Report of Test

Horn, Navy Type H-4

Federal Electric Company,

**NAVAL RESEARCH LABORATORY
ANACOSTIA STATION
WASHINGTON, D. C.**

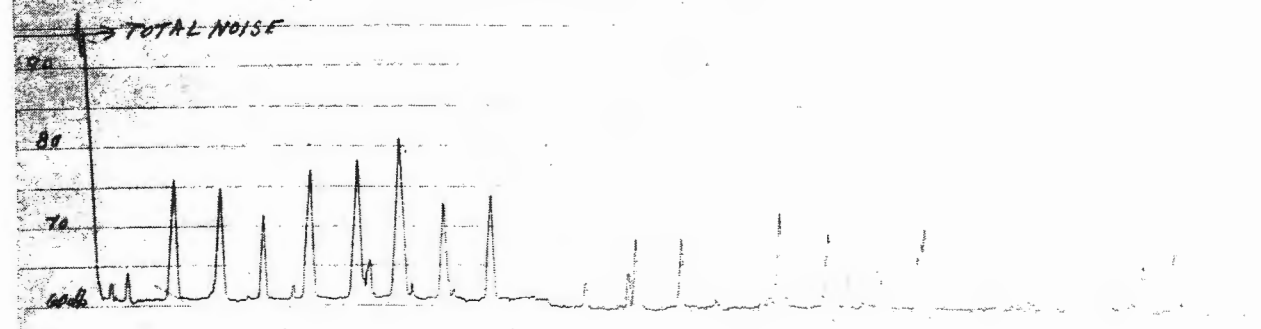
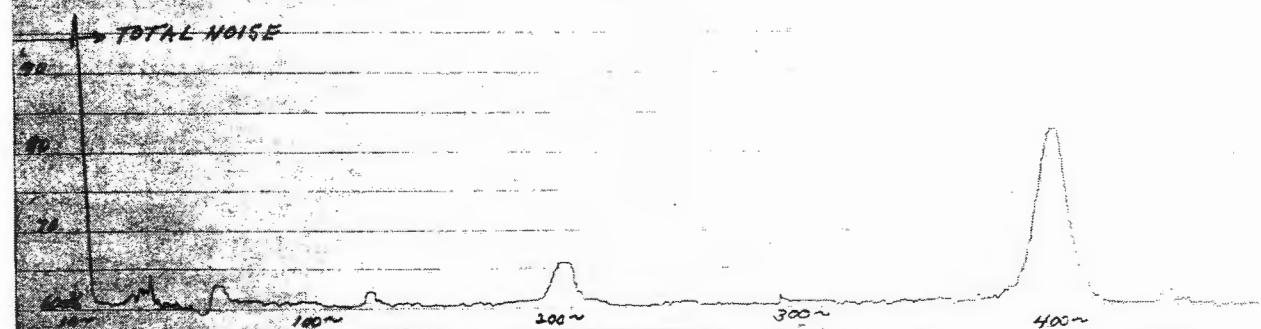
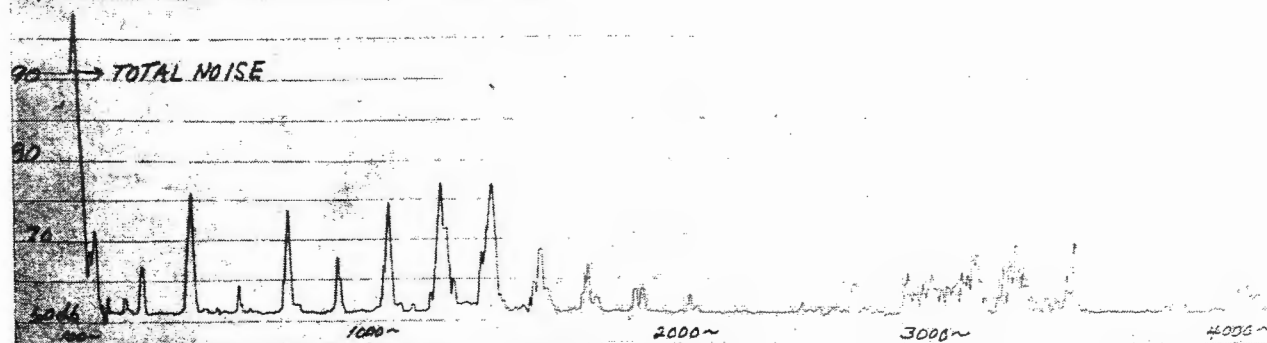
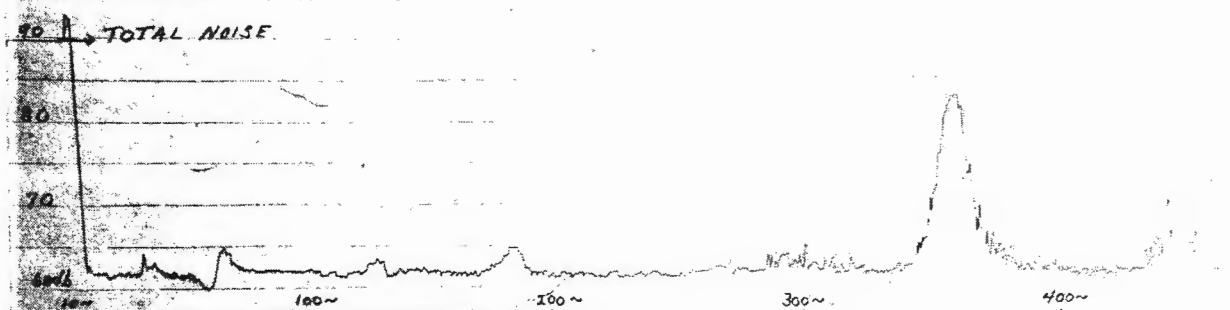
II. The subject horn, manufactured by Federal Electric Company, Chicago, Illinois, as Navy type H-4, complied with the specifications, reference (b), except in the following respects:

- (1) Steel inserts are not provided in housing cover (pc. 2) for machine screws (pc. 69) securing the chassis to the cover.
- (2) One screw (pc. 7) is not accessible, due to its location under projector (pc. 3). Drawing, reference (c), shows two screws so located but, as submitted, the position of projector was as shown by Plate 2.
- (3) Contact spring (pc. 43) is of blued steel.
- (4) Brass spacers (pc. 57) under the terminal block are in contact with aluminum.
- (5) Terminal tube bosses are not correctly located. The specifications require that one be located at the top and one at the bottom.
